<< REPORT OVERVIEW >>

| FTIR No : PR200702B00001 [Automobile] | | Report Date 2007 / 02 / 03 | |
| Subject | RW420 with Code B1312 High Resisance on Pass Sensor | | |

| Subject | JB627 AIR BAG LIGHT | | |

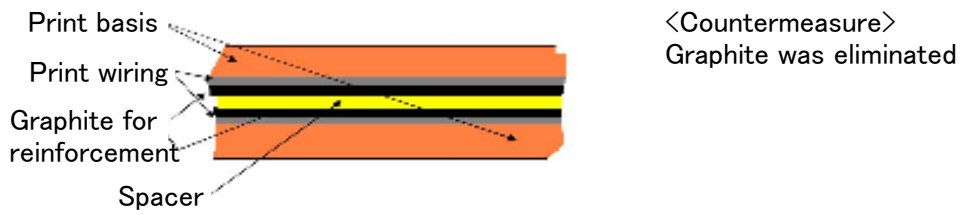
| Feedback | <p><Result></p> <p>1, A minor crack occurred on the print wiring of the sensor mat. Graphite was used for reinforcement. But because of different extensibility between graphite and the print basis, the crack occurred when it was bent.</p> <p>2, A crack occurred on EOL(End of Line resister).</p> <p>3, A crack occurred on the serpentine part in the print wiring</p> <p><Cause></p> <p>The cracks were due to insufficient endurance..</p> <p><Countermeasure></p> <p>1, Graphite was eliminated in order to increase flexibility of the print wiring after Jun, 2008.</p> <p>2, The shape of the resistance was changed from the rectangle to the circle in order to improve the tolerance in occurring a crack.</p> <p>3, The slit on the felt for protection was eliminated in order to ease stress on the serpentine part. The serpentine part was made to thin in order to increase flexibility. The print basis on the fixing parts were eliminated in order to ease stress on the serpentine part.</p> <p><Affected VIN and date></p> <p>JS2YC5A29B [REDACTED]; Mar 23, 2011</p> <p>JS2YB5A35B [REDACTED]; Mar 23, 2011</p> <p>JS2YC5A40B [REDACTED]; Mar 23, 2011</p> <p>JS2YA5A56B [REDACTED]; Mar 23, 2011</p> <p>JS2YA5A73B [REDACTED]; Apr 5, 2011</p> <p>JS2YC5A98B [REDACTED]; Apr 6, 2011</p> <p>JS2YA5A10B [REDACTED]; Apr 5, 2011</p> <p>JS2YA5A25B [REDACTED]; Mar 23, 2011</p> <p>JS2YB5A21B [REDACTED]; Mar 23, 2011</p> <p>Thank you for [REDACTED] information.</p> |

Result of investigation

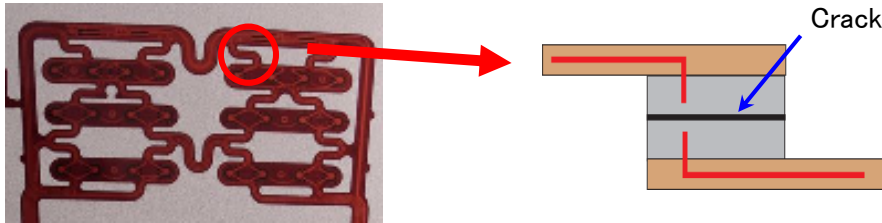
1, A crack on the print wiring of the sensor mat

2, A crack on the print wiring of the sensor mat

<Countermeasure A>

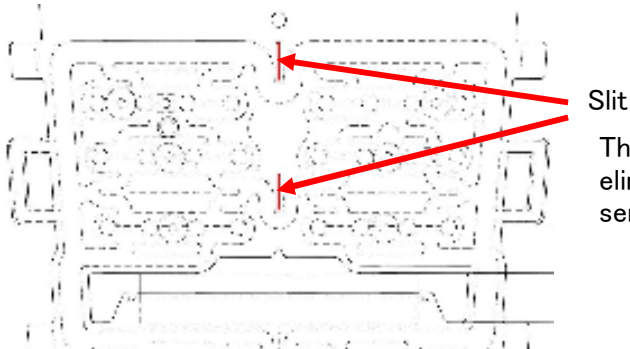
2, A crack on the print wiring of the sensor mat

The slit on the felt for protection was eliminated in order to ease stress on the serpentine part.

Result of investigation

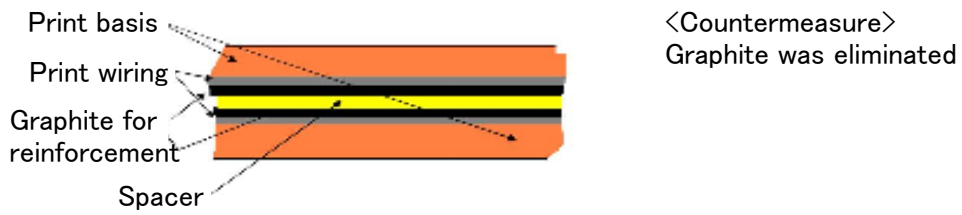
1, A crack on the print wiring of the sensor mat

<Countermeasure A>

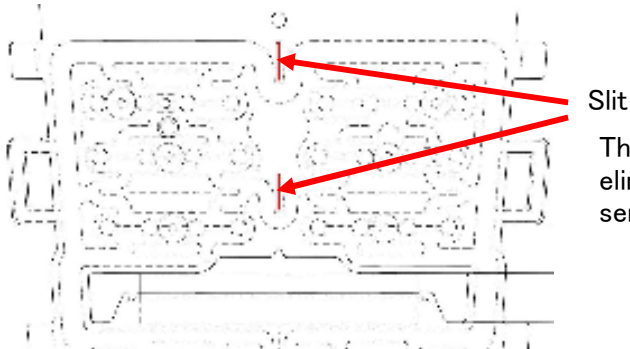
2, A crack on the print wiring of the sensor mat

The slit on the felt for protection was eliminated in order to ease stress on the serpentine part.

CUSHION ASSY,FRONT P/N: 85101-65JQ0-BFG

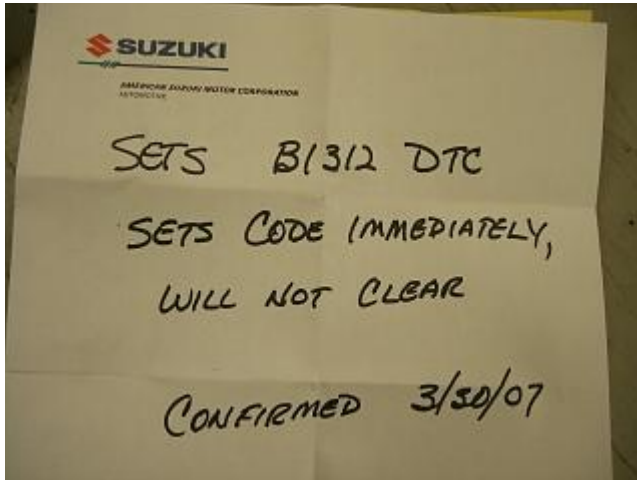
The seat cushion was installed on a known good vehicle and confirmed that the air bag light came on immediately and B1312 code stored. The DTC can not be cleared with Tech-II

Inspection of Intermittent and Poor Connections

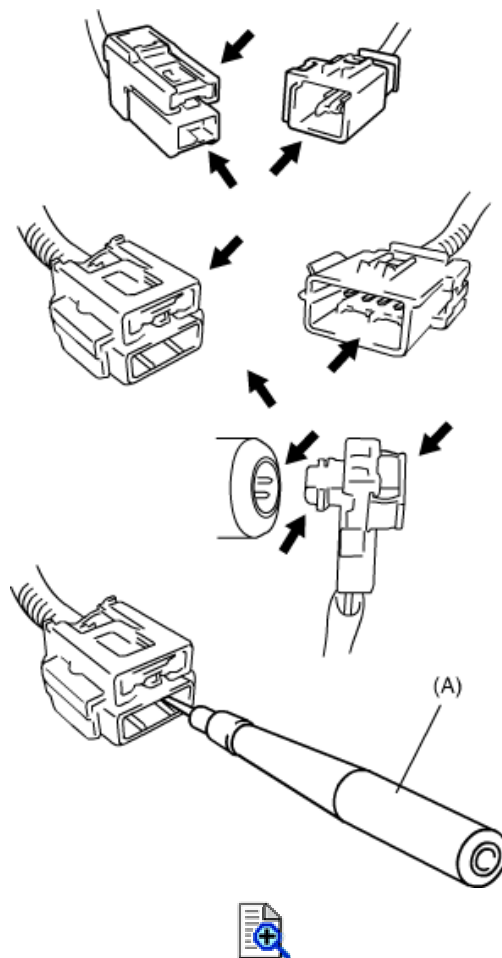
| Feedback | <p><SMC'S COMMENT> According to the description of this FTIR, intermittent bad electrical contact can be considered. However, we were not able to investigate this matter because no incident parts are available. In view of this, we will not take any further action at this stage. If you find more case, please check the electrical connections by referring service manual as attached.</p> <p>Thank you for your information.</p> | | |

Most intermittent connections are caused by faulty electrical connections or wiring. When a check for proper connection is requested in a diagnostic flow, perform careful check of suspect circuits.

If any abnormality is found, repair or replace as a wire harness assembly.

- Poor connection of terminal and wire.
Check each wire harness in problem circuits for poor connection by shaking it by hand lightly. If any abnormal condition is found, change the wire harness assembly or component parts with new ones.
